Access Compliance Report

Public Rights-of-Way

Intersection ID: 3390		Main Street: CRAYTON_DR		Cross Street: MANBEY_CT		Location: NE											
ADA ID: 69BCFC1DA9A2		Ramp Type: Directional1		Initial Pass/Fail: Pass		Overall Compliance: No		Severity Score: 0.25									
Codes/Mitigation Info/Possible Solution				Field Measurements/Component Compliance													
<div></div> <div>Street 1 NameMANBEY CT</div> <div>Stop Condition-Street 1None</div> <div>Street 2 NameN/A</div> <div>Stop Condition-Street 2N/A</div>				Possible Solutions:		Compliance		Description		Data		Compliance		Description		Data	
				Remove & Replace Entire Ramp.		N/A		Ramp Length (in)		52.0		Yes		Grade Break?		Yes	
Surveyor Notes:				N/A		Yes		Ramp Width (in)		48.0		No		Grade Break Slope (%)		6.6	
						Yes		Ramp Slope (%)		4.4		No		Grade Break XSlope (%)		4.1	
PROW/ADA:				R304.5.3, R304.2.1, R304.2.2-Perp, R304.3.2-Para		No		Ramp XSlope (%)		2.1		N/A		Flare Type LT		N/A	
						N/A		Flare Slope LT (%)		N/A		N/A		Flare Slope RT (%)		N/A

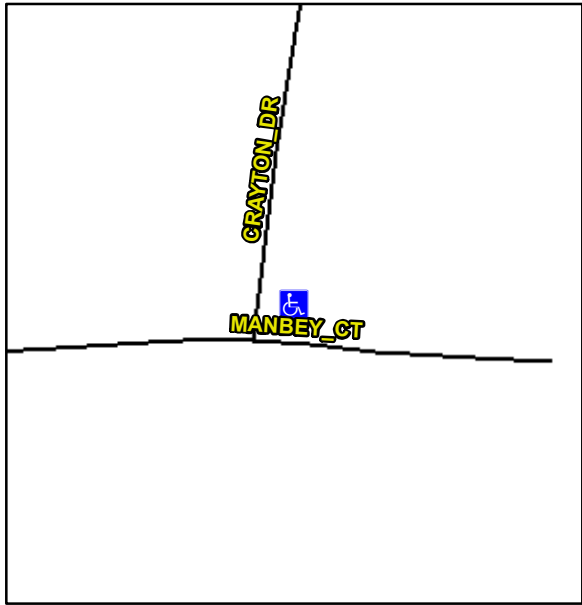
N/A		Flare Traversable LT?		N/A		N/A		Flare Traversable RT?		N/A	
						Yes		Landing Length (in)		53.0		Yes		DWS Provided?		Yes	
						No		Landing Width (in)		46.0		Yes		DWS Contrast?		Yes	
						No		Landing Slope (%)		5.9		Yes		DWS Length (in)		24.0	
						Yes		Landing X Slope (%)		1.0		Yes		DWS Full Width?		Yes	
						N/A		Landing Curb? (Y/N)		No		Yes		DWS Offset LT (in)		0.0	
						N/A		Shared Landing?		No		Yes		DWS Offset RT (in)		45.0	
						Yes		Gutter Ponding?		No		Yes		Gutter Slope (%)		0.2	
						Yes		Gutter Lip Ht (in)		0.0		Yes		Gutter X Slope (%)		1.7	
						N/A		Painted X Walk1?		No				Road Slope (%)		0.8	
								X Walk 1 Direction		To S				Road X Slope (%)		1.7	
								X Walk 1 Width (in)		N/A				Clear Space?		Yes	
								X Walk 1 Slope (%)		0.8		N/A		Clear Space to XWalk (in)		N/A	
								X Walk 1 X Slope (%)		1.7		Yes		Storm Grate/Utility Hazard?		No	
						N/A		Ramp inside XWalk1?		N/A				Storm Grate/Utility Type

Yes		Any Obstructions?		No						N/A	
								Obstruction Type				Yes		Surface Condition? (G/P)		Good	
										N/A		N/A		Curb Slope (%)		5.8	
				Total Cost:		\$		1600.00
